ADDENDUM NO: 01

PROJECT: Center Grove MS Central Renovation

PROJECT NO: 2024017 DATE: June 25, 2025 BY: Jack Leibham

A601

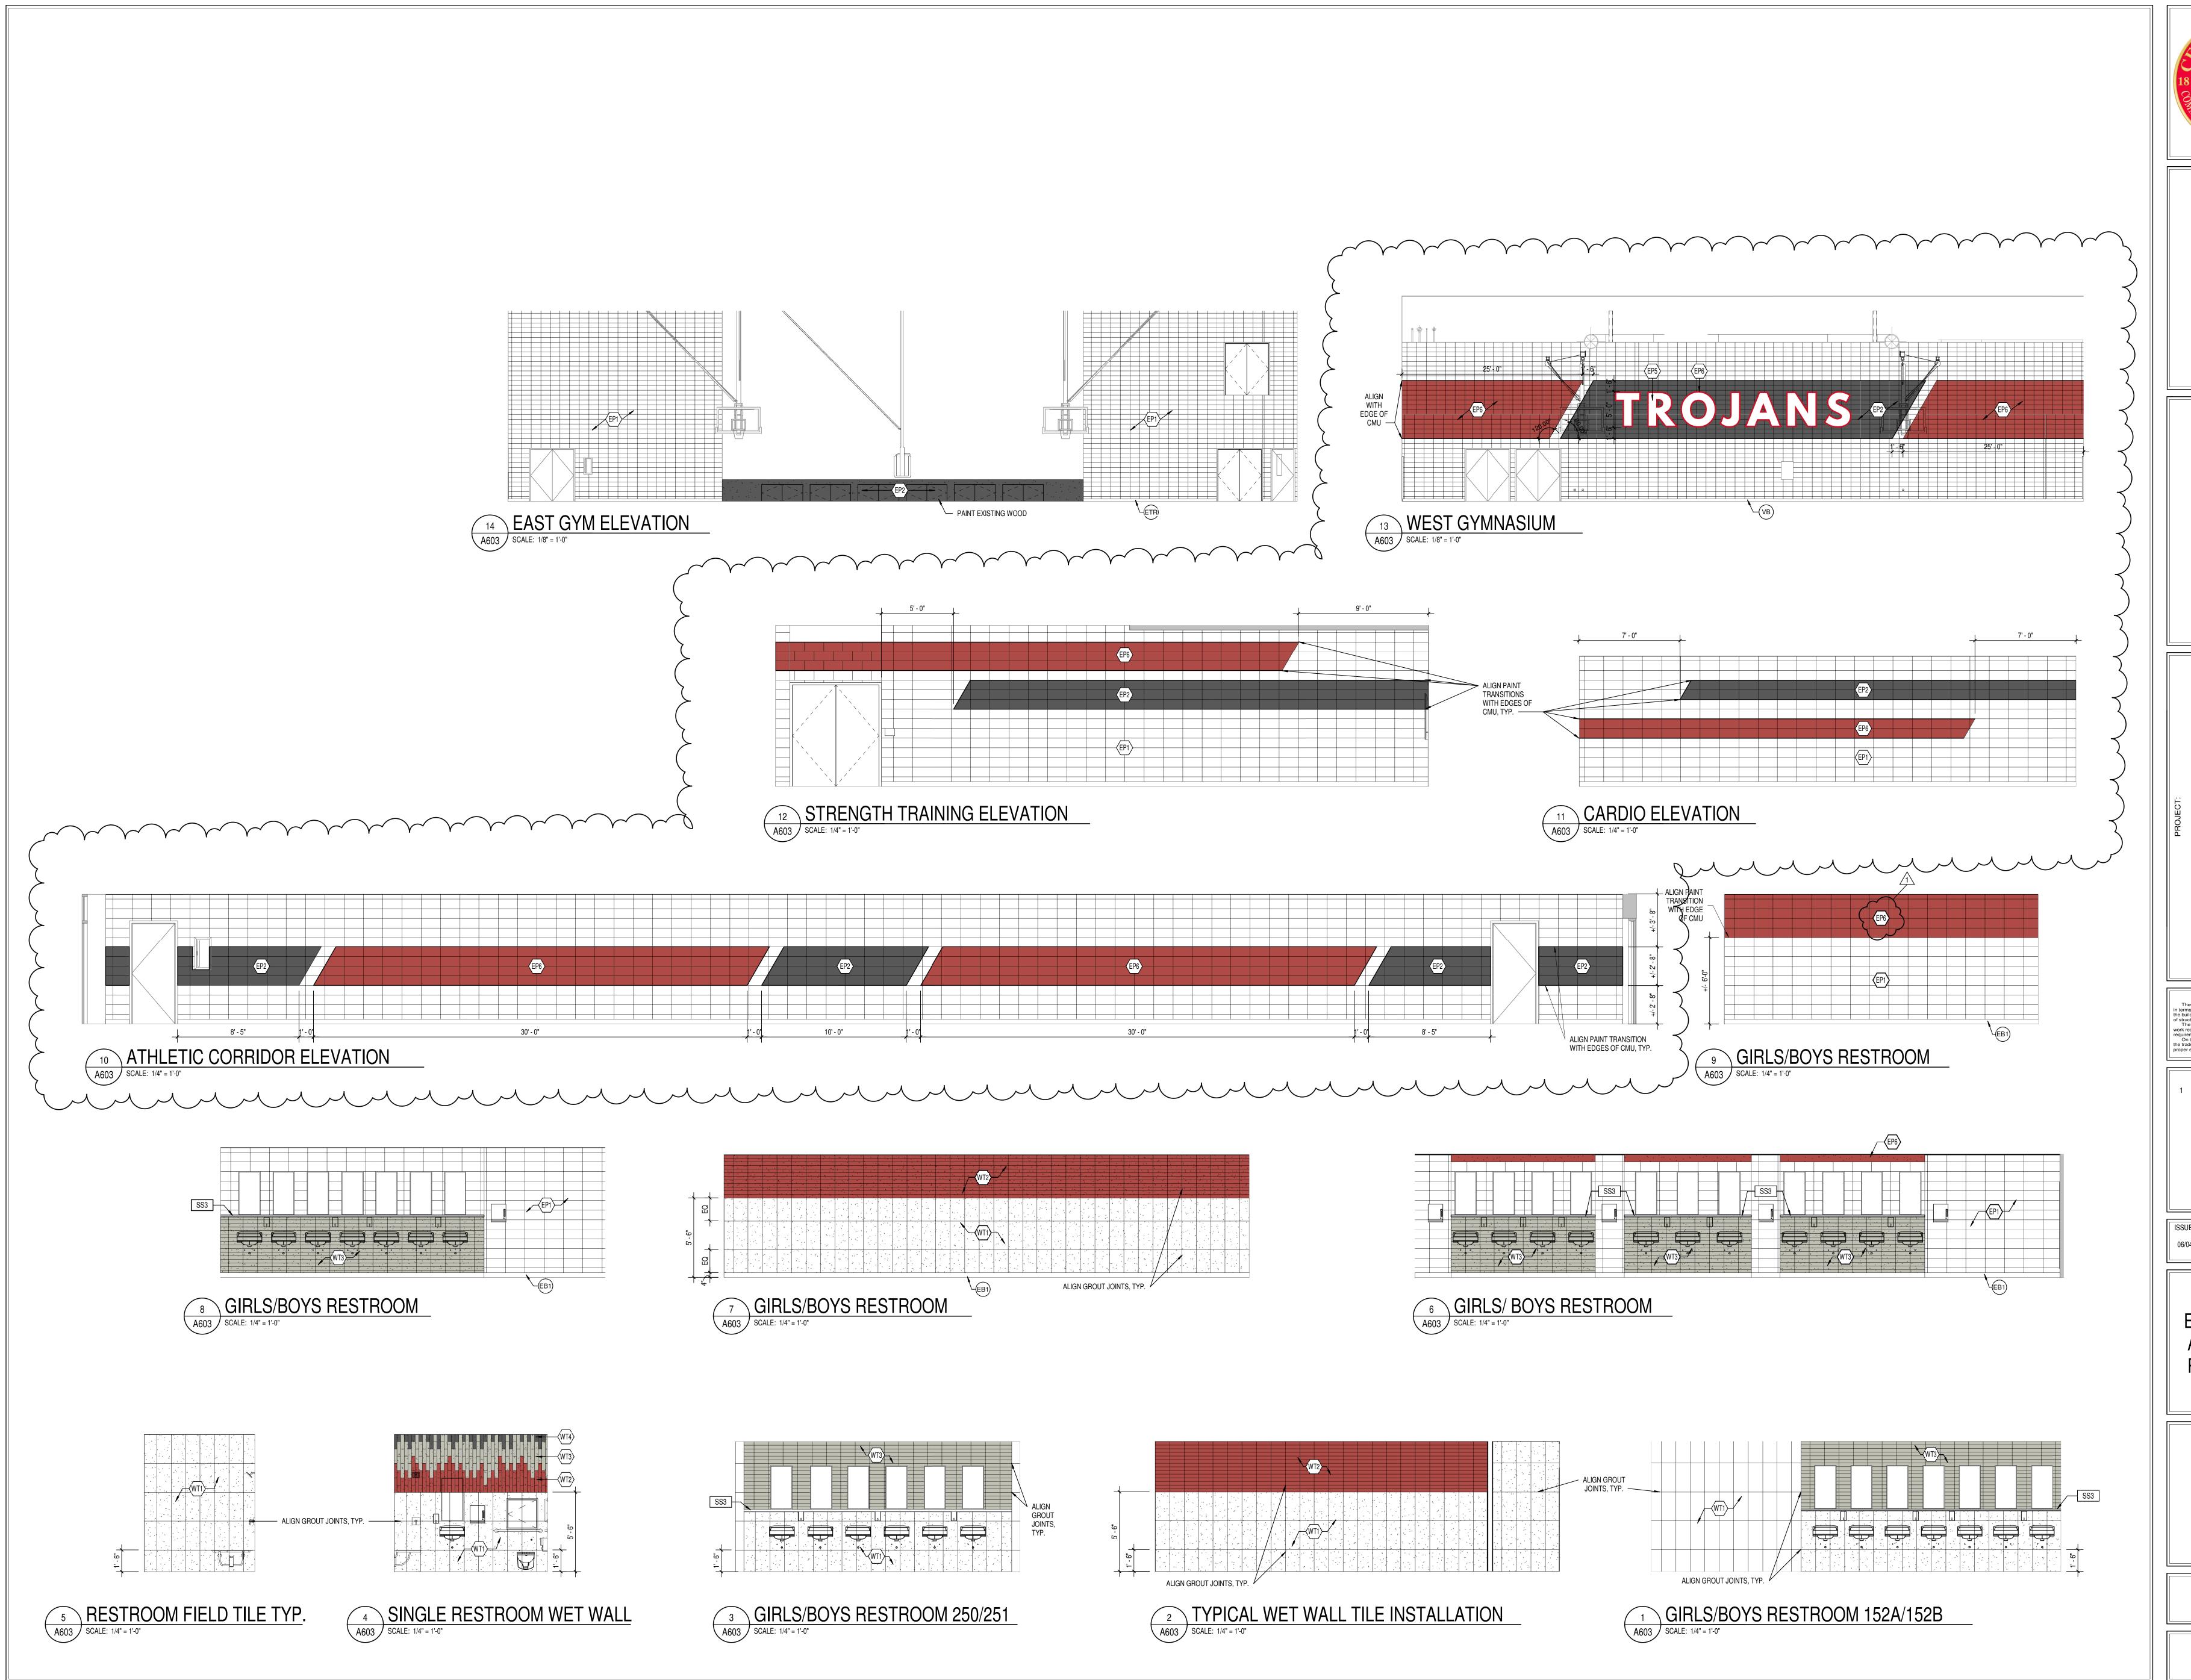
- A. Add dimension and note to 3/A601
- B. Add dimension and note to 8/A601

A603

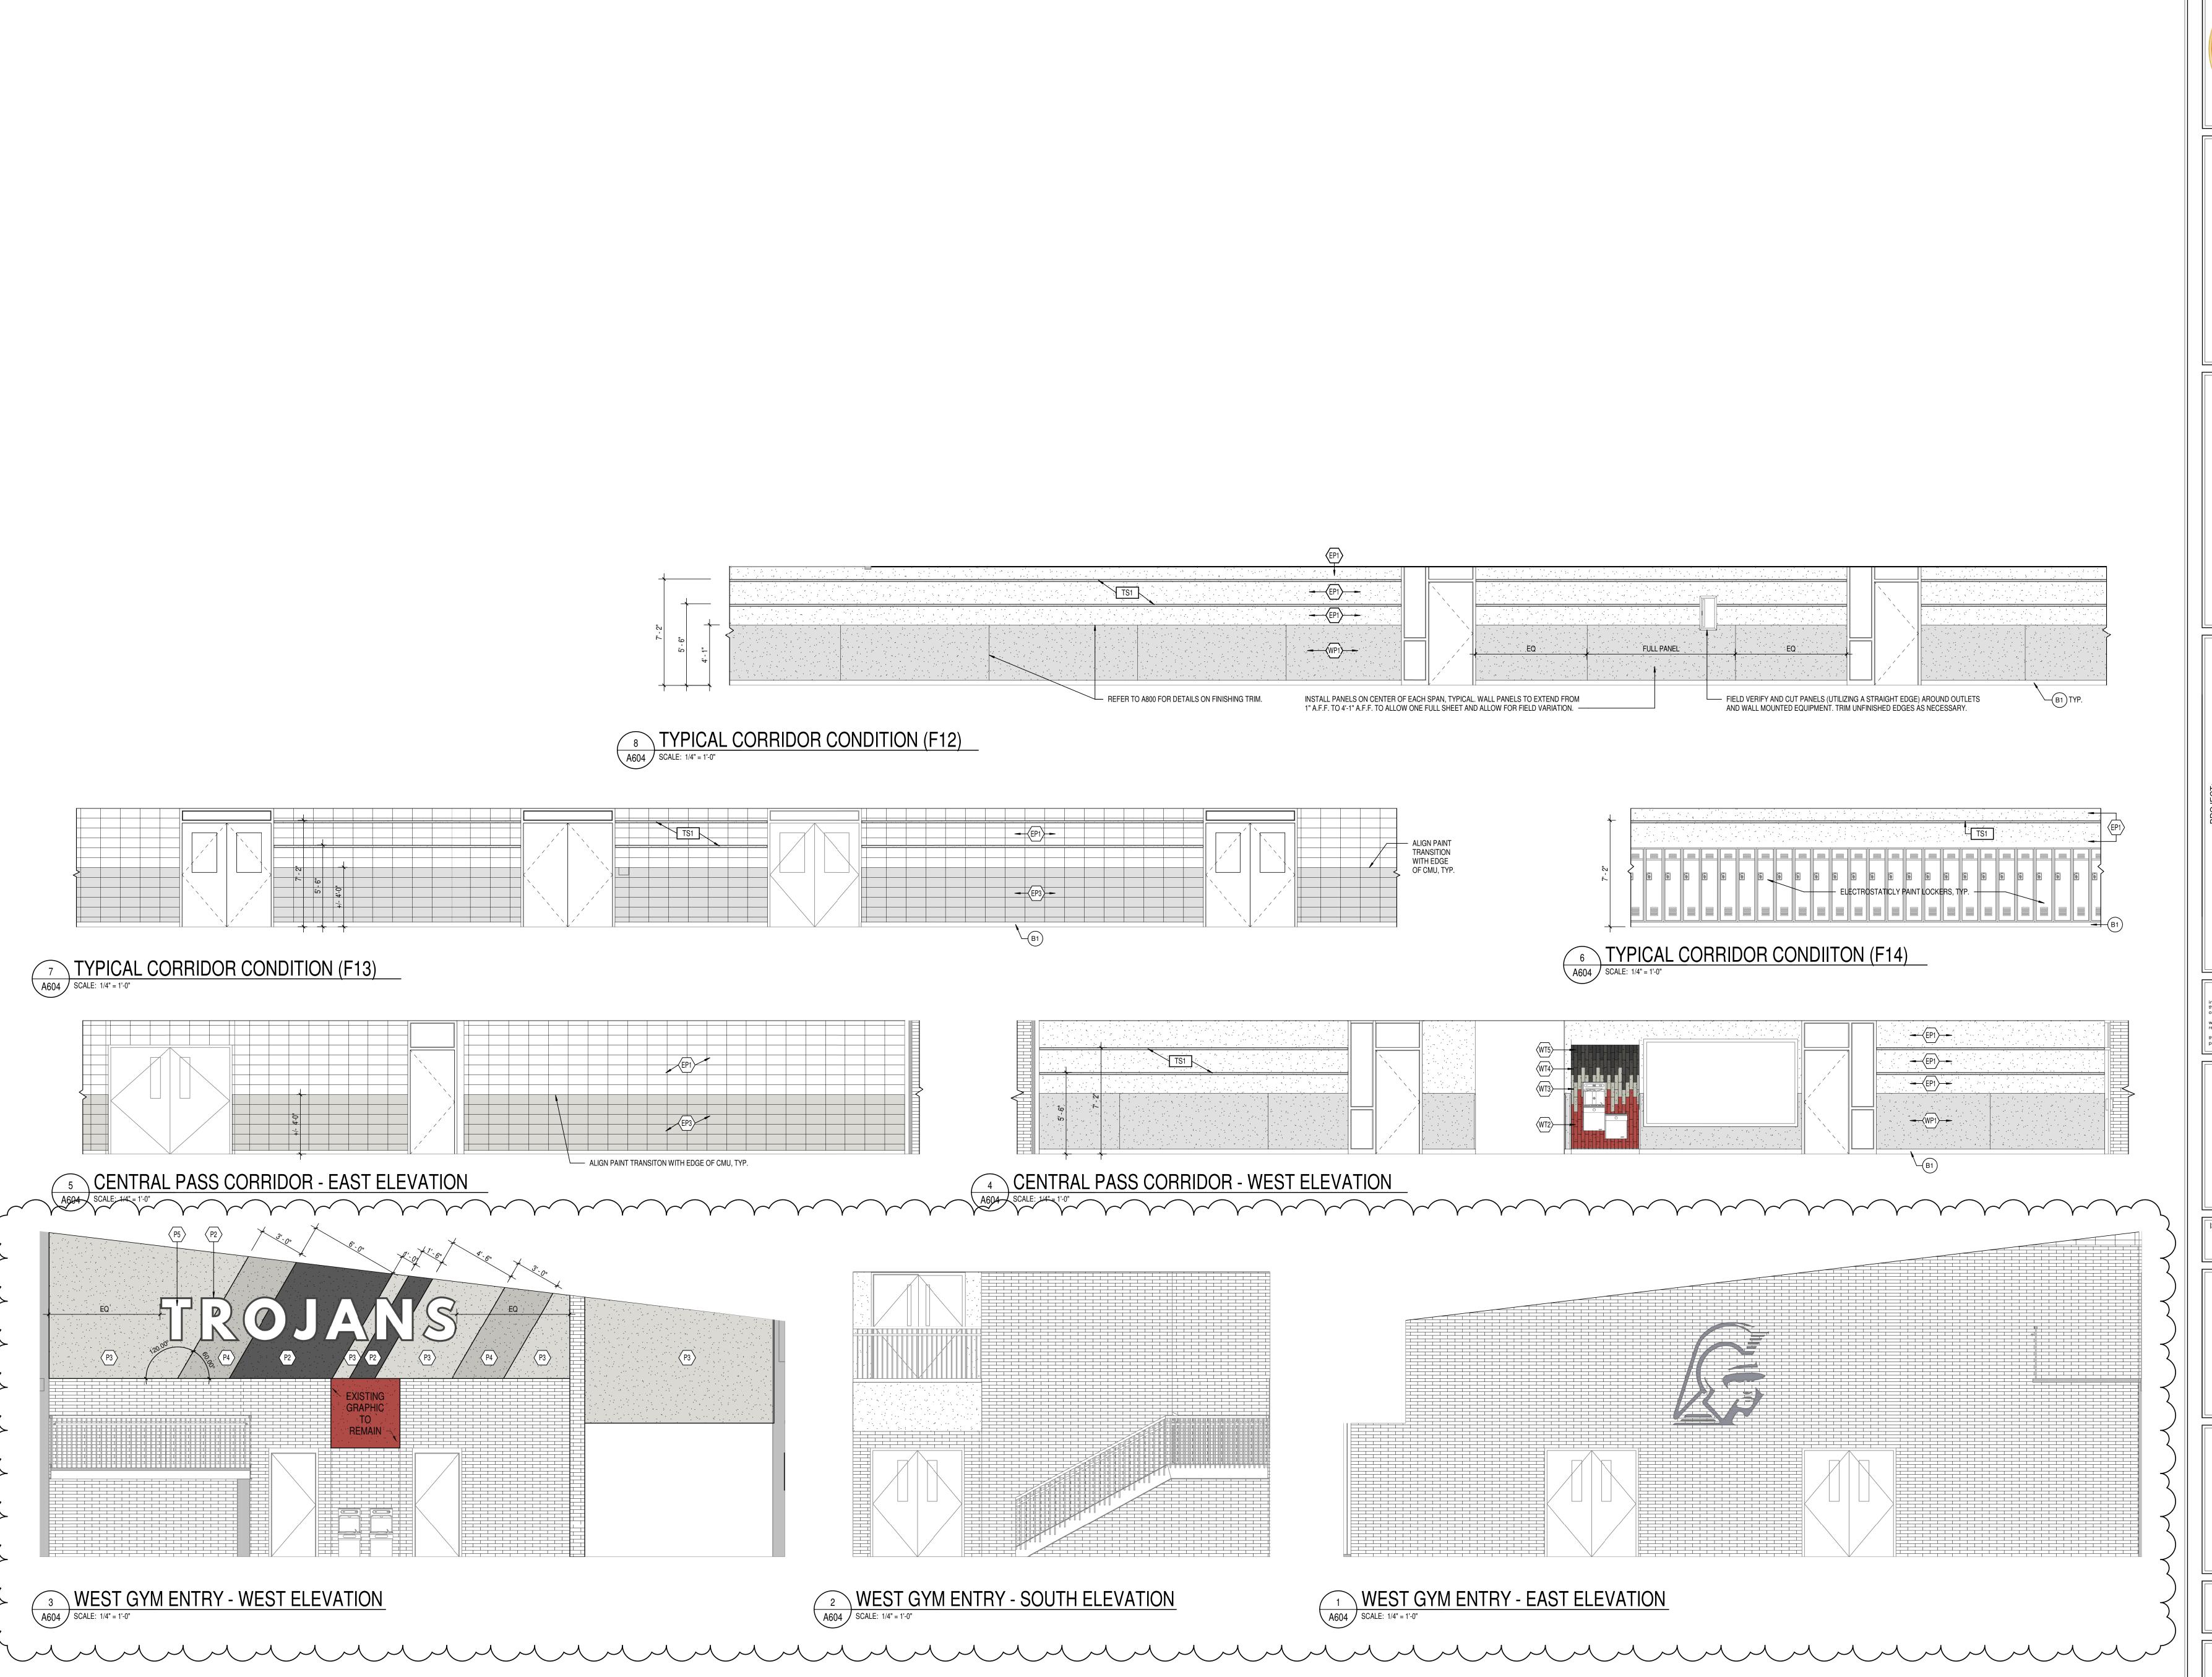
- A. Revise EP8 to EP6 on 9/A603
- B. Revise painted graphics as indicated on 10/A603, 11/A603, 12/A603, 13/A603

A604

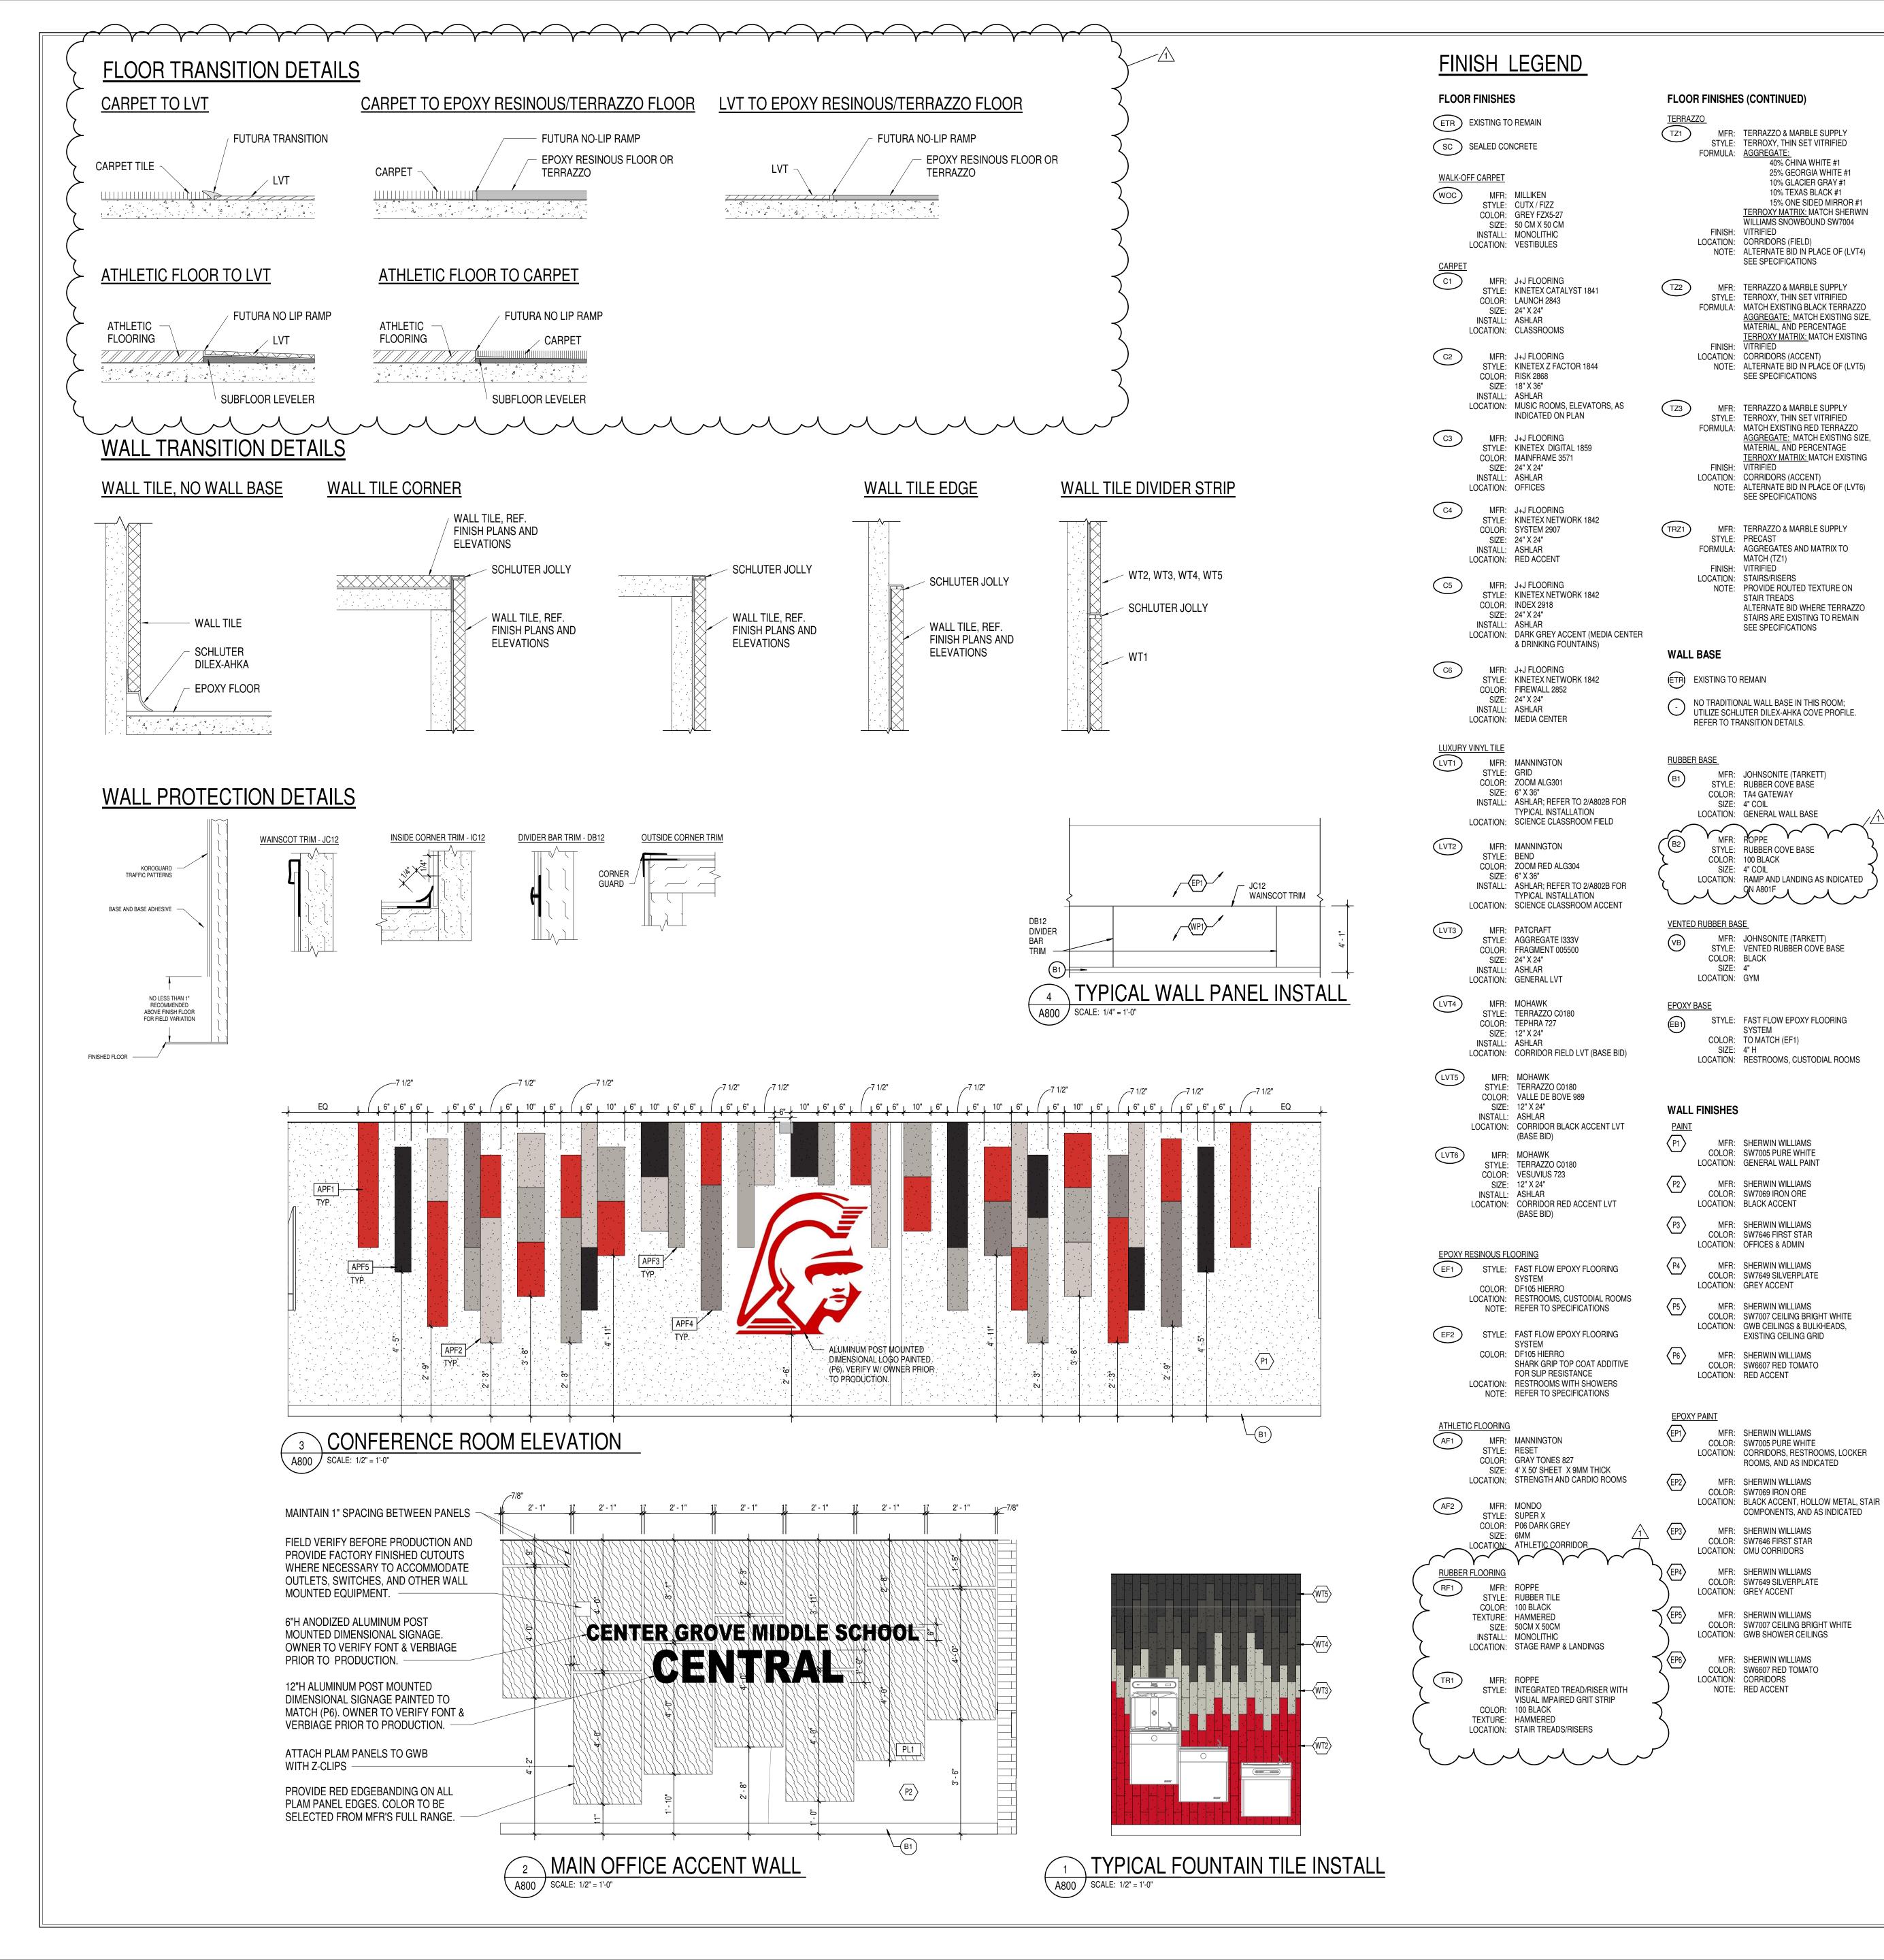
- A. Add dimensional trojan signage as indicated on 1/A604
- B. Revise wall type as indicated in 2/A604
- C. Revise wall types and add painted graphics as indicated on 3/A604
